CHATHAM COUNTY PURCHASING DEPARTMENT
ADDENDUM NO. 3 TO ITB # 17-0074-4

FOR: MEMORIAL STADIUM

ADDENDUM NO. 3

CHANGES TO PROJECT DRAWINGS:

Drawing No.:
SR102

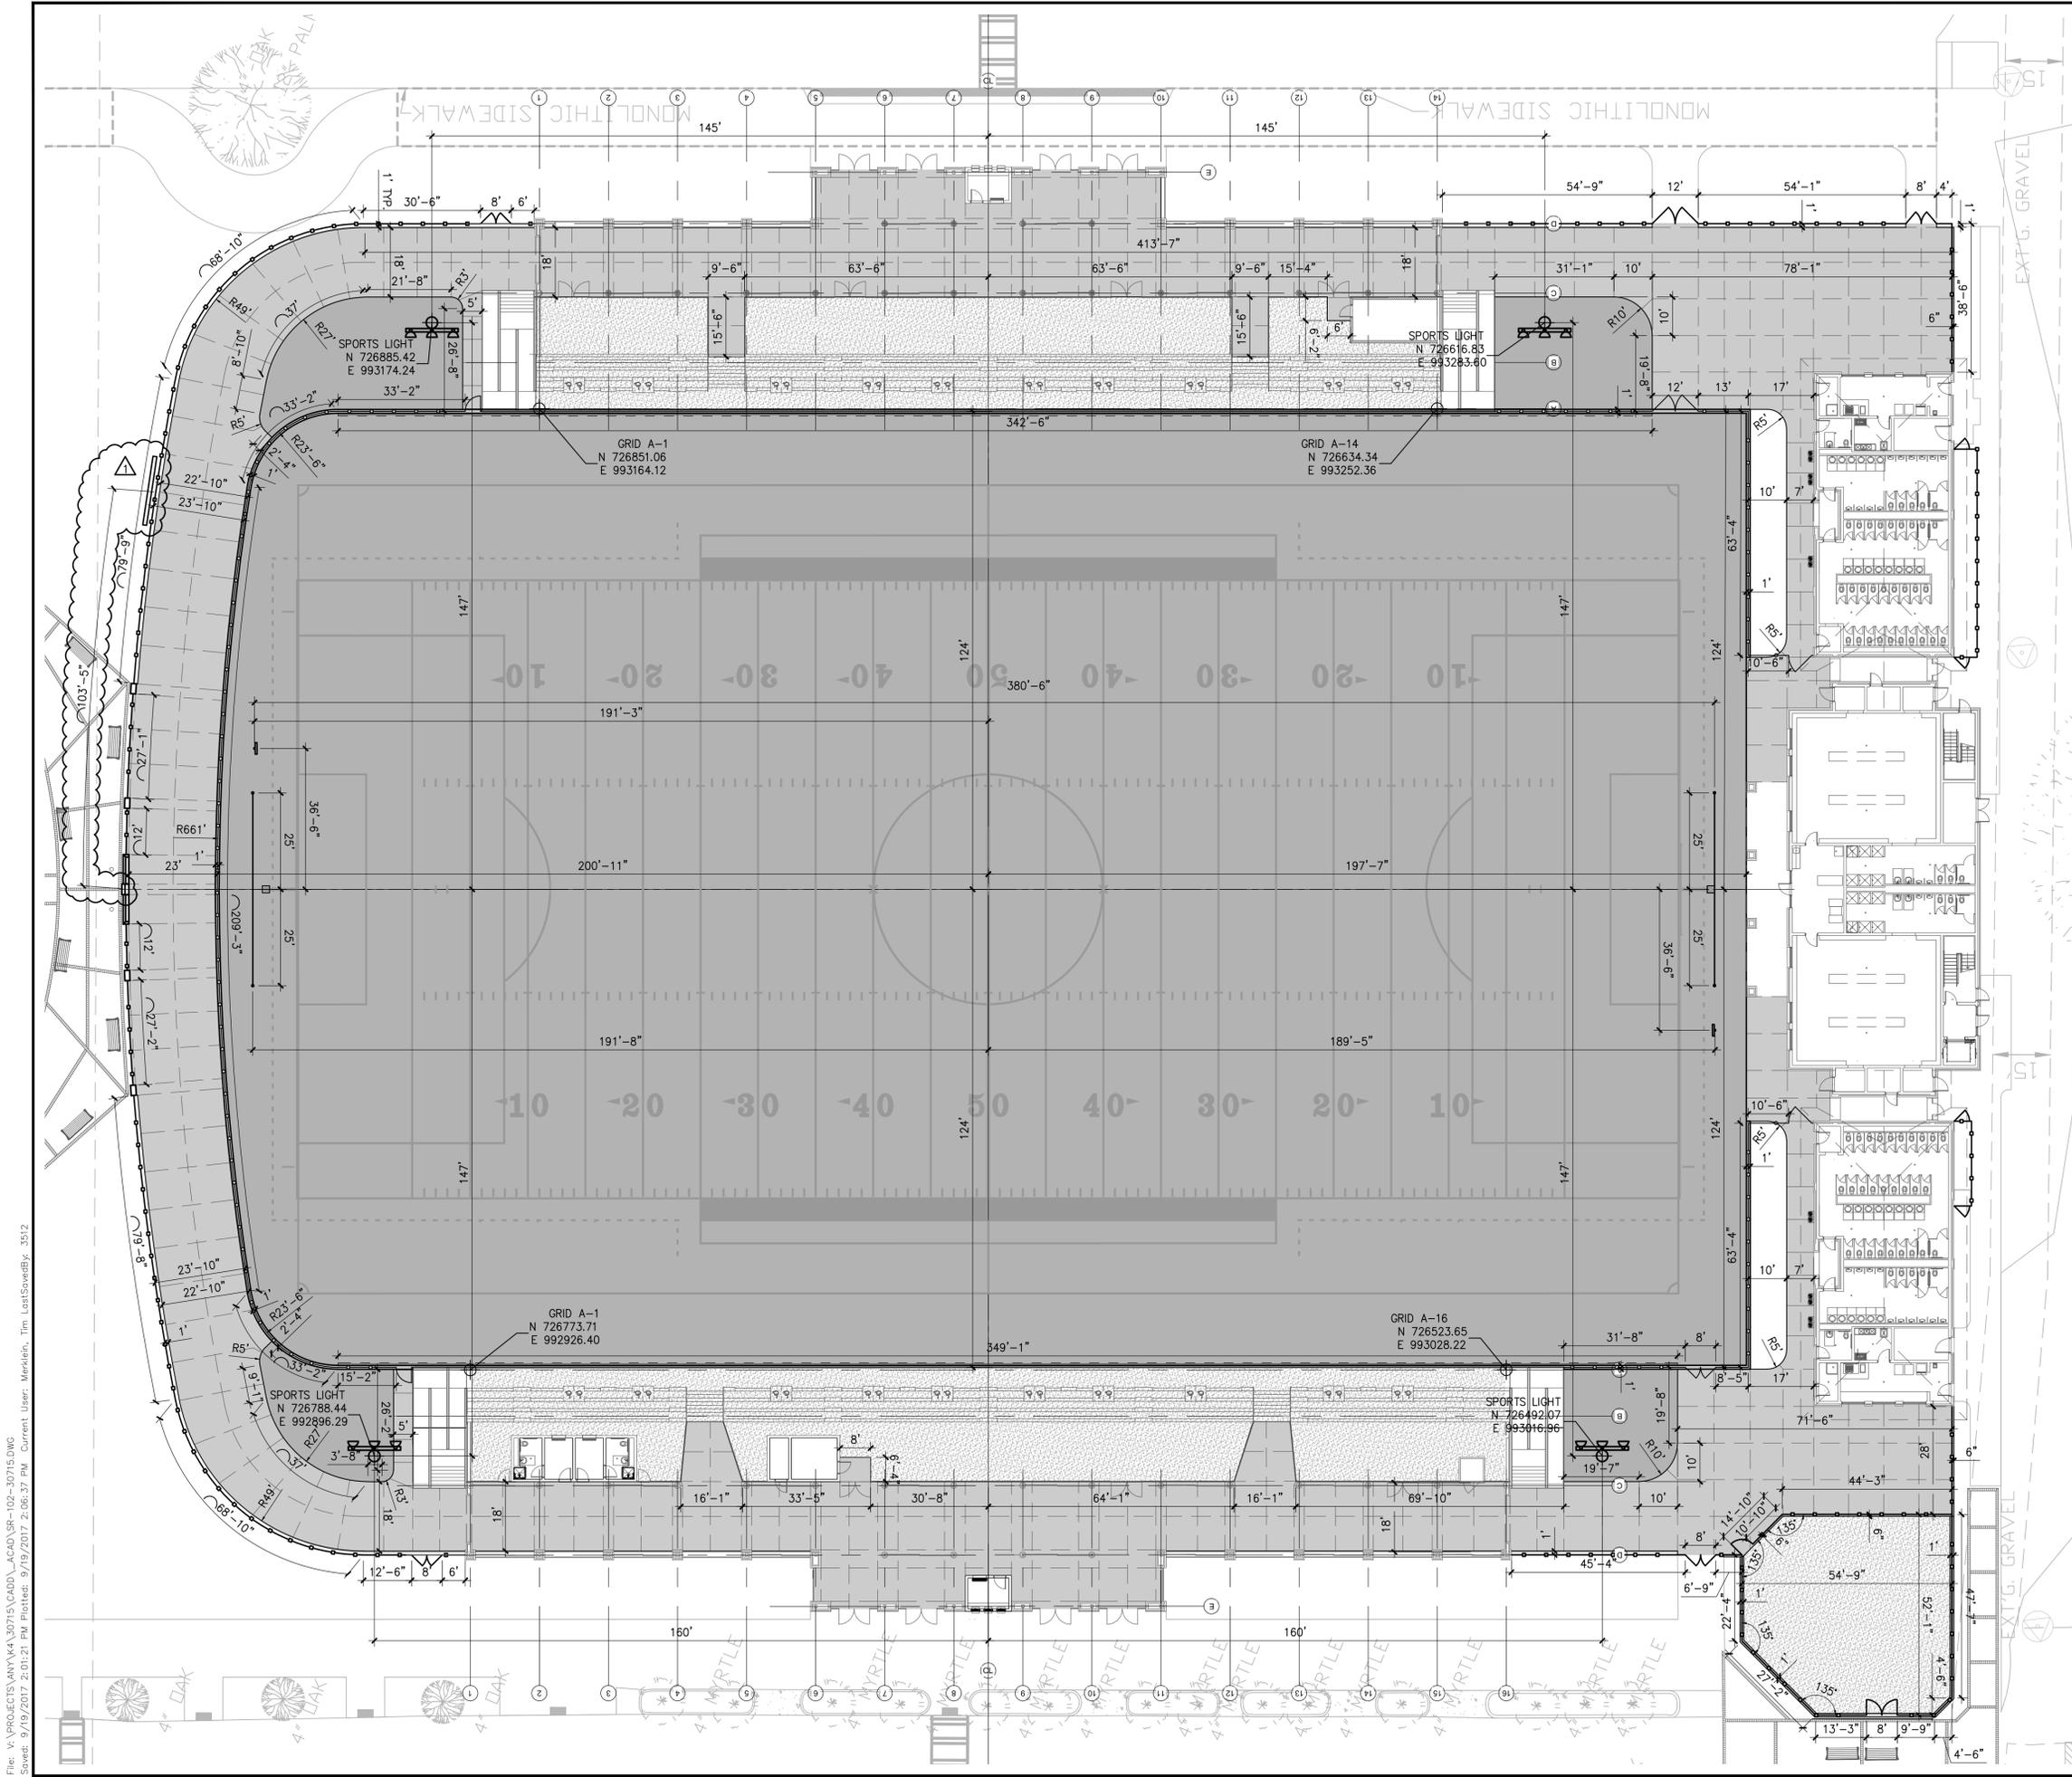
18. Question: The football scoreboard, called for in spec section 116843, is not shown on the Field Layout Plan, SR101; however, note 17 on sheet CE-002, which calls out the power requirements for the scoreboard is shown in the NE corner of the project. Please confirm that is the location of the scoreboard and provide a similar detail to detail 5, SR603, which shows the components and foundation for the play clocks.
Answer: Revised Drawings SR-101, SR-102, SR-111, & SR-604 address these scoreboard questions.

7 FIELD CURB SECTION AT CHAIN LINK FENCE
SECTION SCALE: 1-1/2" = 1'-0"

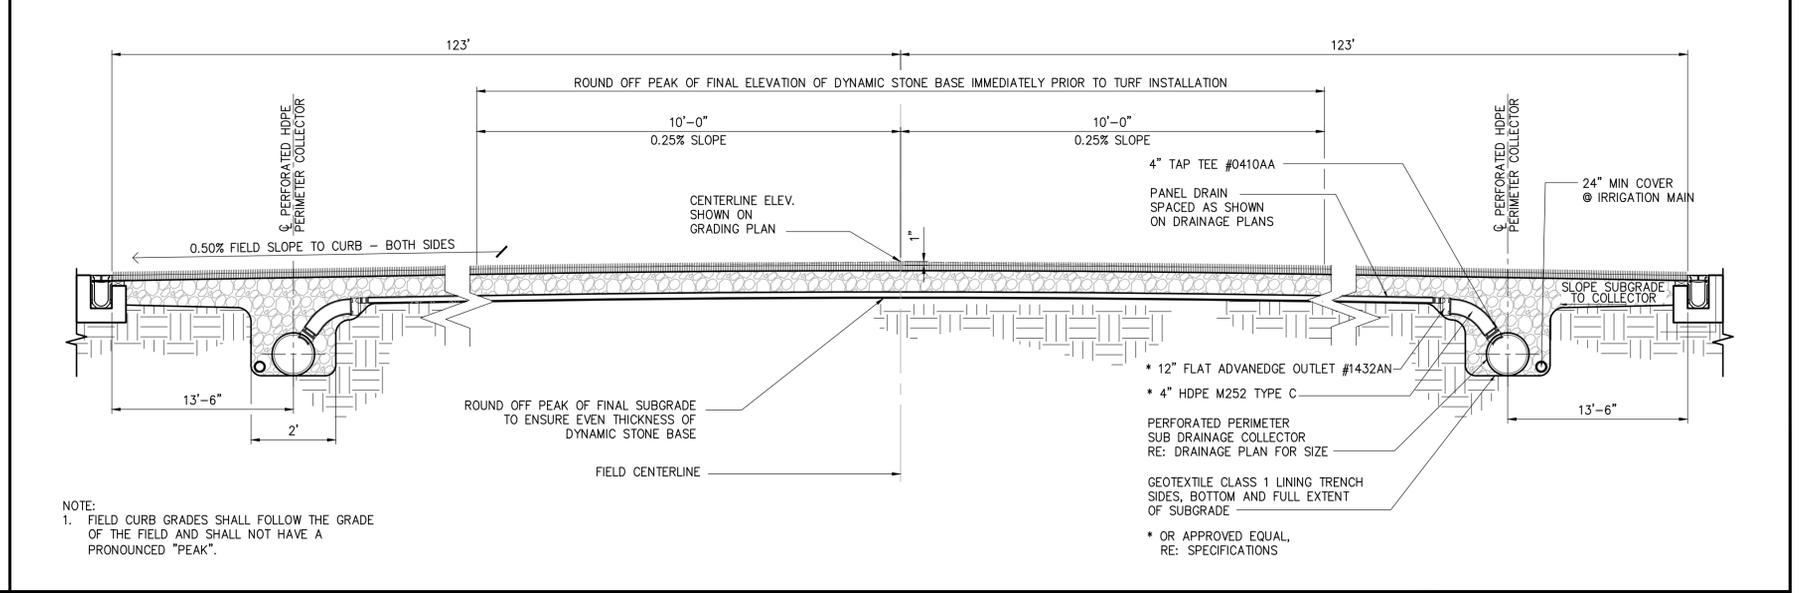
Answer: Please see attached Dumpster Enclosure Detail.
28. Question: On SR101- there are two references to detail 7 on SR601. However, there is NOT a detail shown for detail 7 on SR 601. What detail applies at this location?

Answer: Revised Drawing SR-601 addresses the missing detail #7/SR-601.
29. Question: EB1 Johnsonite Millwork base, can you clarify a style and color selection along with size.

4 QUICK COUPLER BOX
PLAN SCALE: 1" = 1'-0"

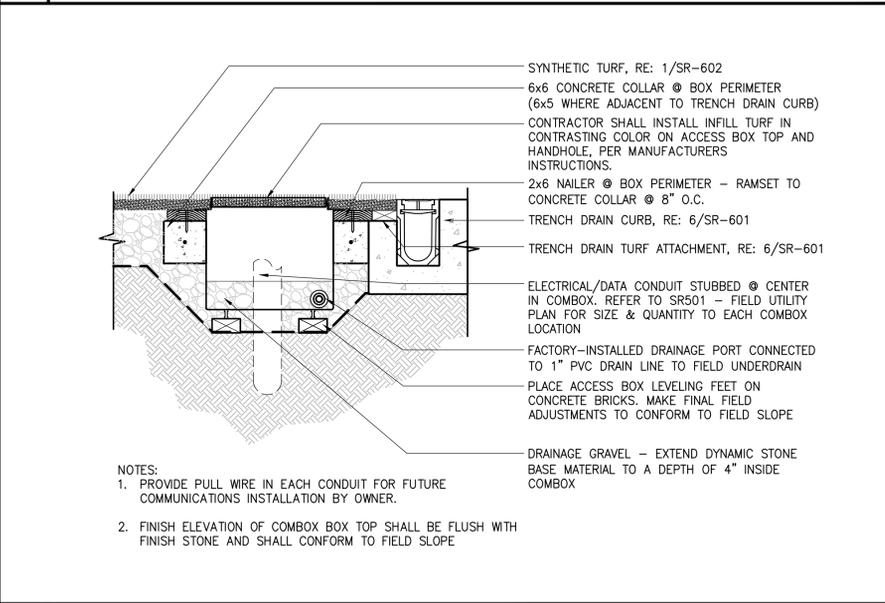
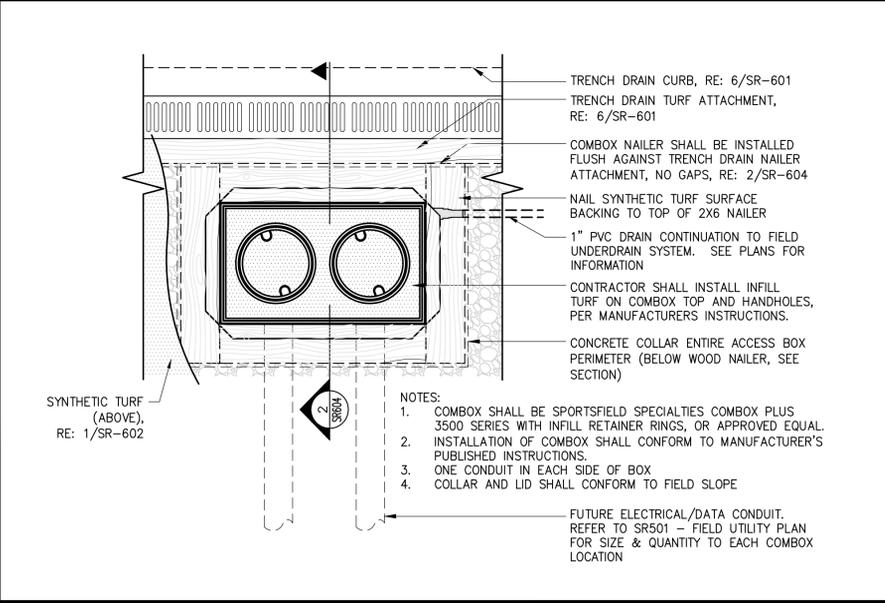
40. Question: I noticed that the plans call for (2 quantity) ComBoxes on both sides of the field at the 50 yard line, however how many Quick Coupler / ComBox Plus 3500.5 Half Boxes are there?

Answer: There are two full-sized Comboxes: one along each sideline at 50 yds, and two Quick Connect Valve Boxes, one along each sideline near 50 yds.
Note #1 of Detail #4/SR-604 should be revised to read: "QUICK COUPLER ACCESS BOX SHALL BE SPORTSFIELD SPECIALTIES TURFCOOL QUICK CONNECT VALVE BOX FOR SYNTHETIC TURF APPLICATION, OR APPROVED EQUAL."

1 ENLARGED PLAYGROUND LAYOUT
 PLAN SCALE: 1" = 5'-0"

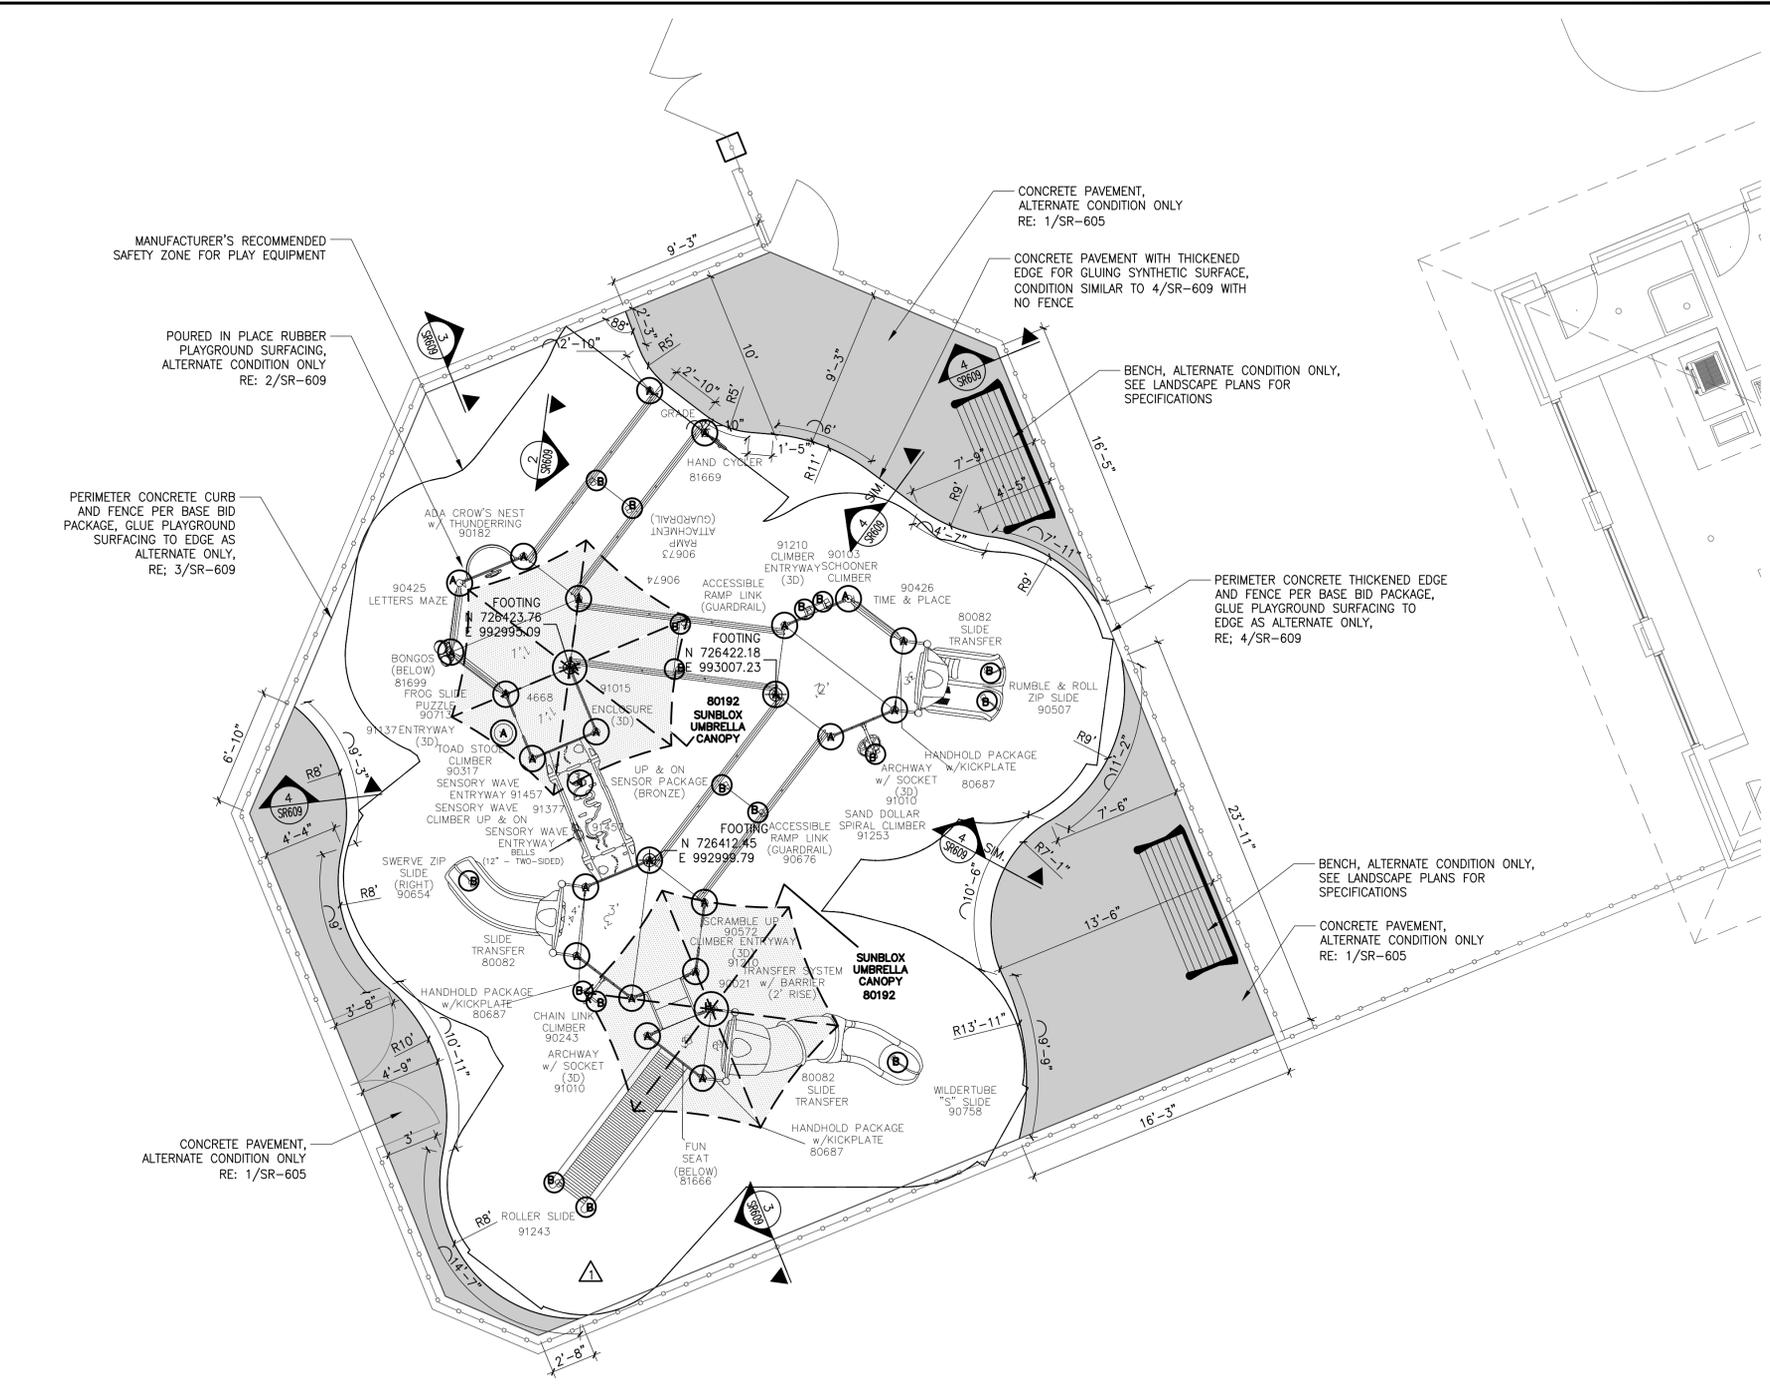
20. Question: The dark shading on SR609, makes it difficult to see the different components for the playground equipment. Please issue a drawing with no shading.
Answer: Revised Drawing SR-609 addresses the legibility of the hatch and the playground text.
